TECHNICAL BULLETIN  
K192NAS1  
07 APR 2014

**SB-10056416-2269**

Service Action: Folding Top Enhancement Program

**F-TYPE (X152)**

E162496

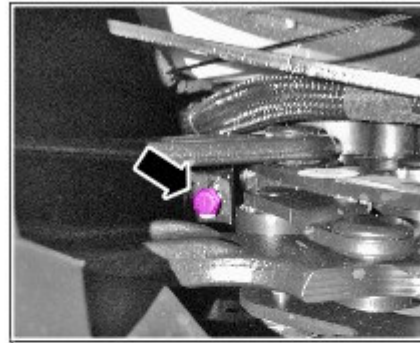
1. With the folding top in the open position, assess the gap from the folding top to the secondary folding top flap. It should be at least 2mm (vertically) and even across the vehicle.
  - If the gap is OK (no contact present), continue to Folding Top Harness - Check/Adjust or Replace.
  - If the gap is not OK (contact present), continue to step 2.

**2. Adjust the gap from the folding top to the secondary folding top flap:**

- Lift the folding top to the halfway position; make sure the folding top flaps are fully raised.
- Locate the downstop (see fleck of yellow paint) and use an 11mm socket and extension to raise or lower the folding top (clockwise lowers / anti-clockwise raises the folding top).
- Any adjustment should be made in half-turn increments (either way) up to a maximum of two (2) turns.
- Open the folding top and assess the gap from the folding top to the secondary folding top flap. It should be at least 2mm (vertically) and even across the vehicle.

E162497

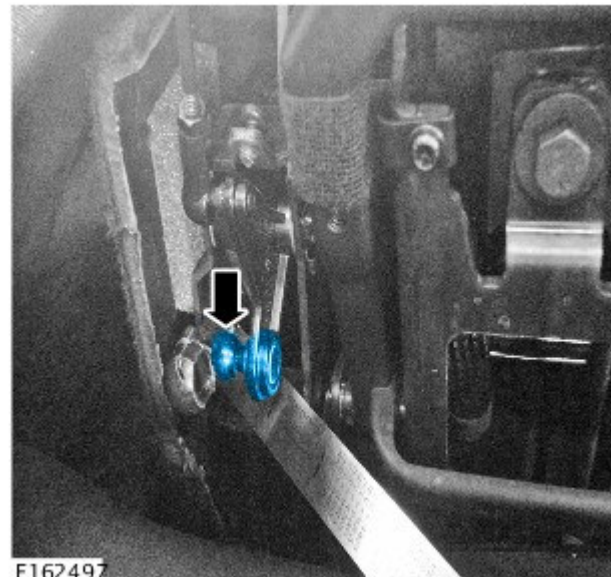
3. If contact is still present, adjust the 'Down lock-to-flaps link rod' one (1) turn (clockwise [inboard] lowers the secondary folding top / anti-clockwise [outboard] raises the secondary folding top flap).

E162498

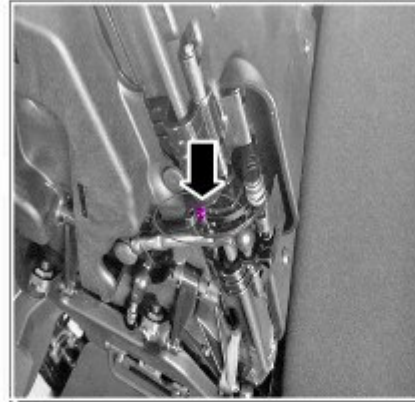
4. Further adjustment can be achieved by turning the secondary folding top flap cap screw clockwise.

E162499

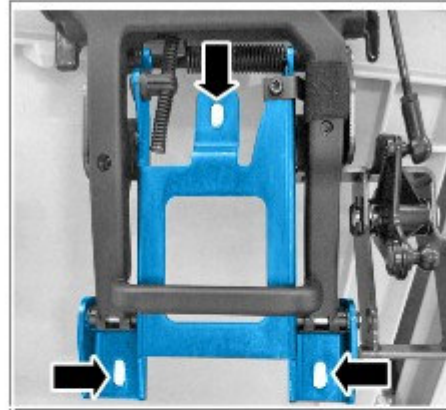
5. In extreme cases, remove the secondary folding top flap assembly mounting bracket, modify the slots to create forward and backward adjustment using a suitable tool.

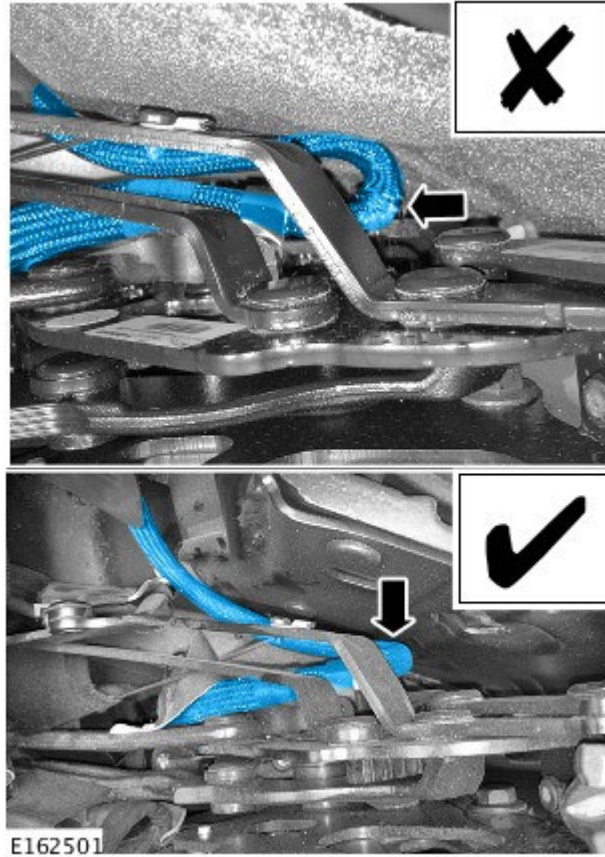
7.  **NOTE: Right-hand harness shown.**

Inspect the right-hand harness; make sure right-hand harness is looped below the link and pulled down rather than trapped horizontally against the foam.

8. If the harness is positioned incorrectly, disconnect the harness to manipulate it to the correct position.

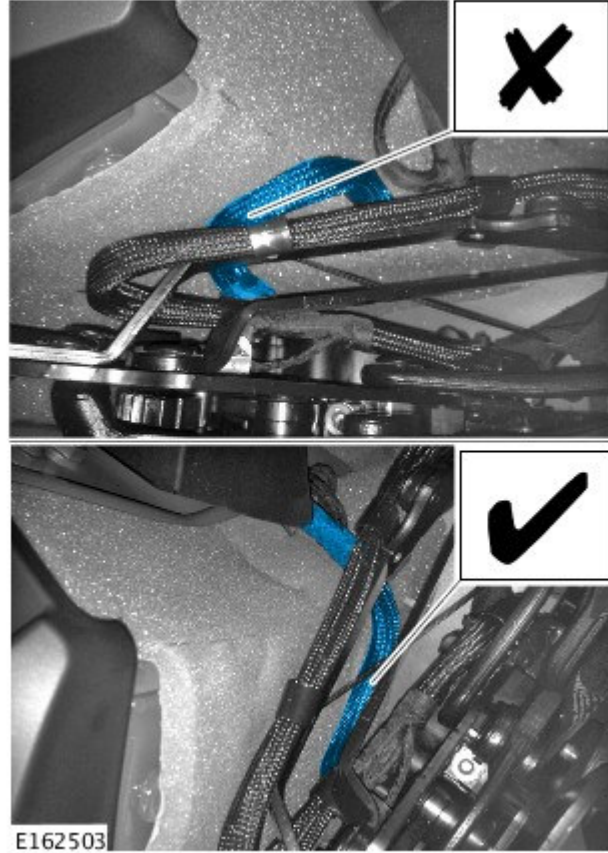
9.  **NOTE: Left-hand harness shown.**

Inspect the left-hand harness; make sure left-hand harness is looped below the link and pulled down rather than trapped between the link and the foam.

- If the harness is routed correctly, continue to Tape Header Trim.
- If the harness is not routed correctly, disconnect the harness to manipulate it to the correct position..
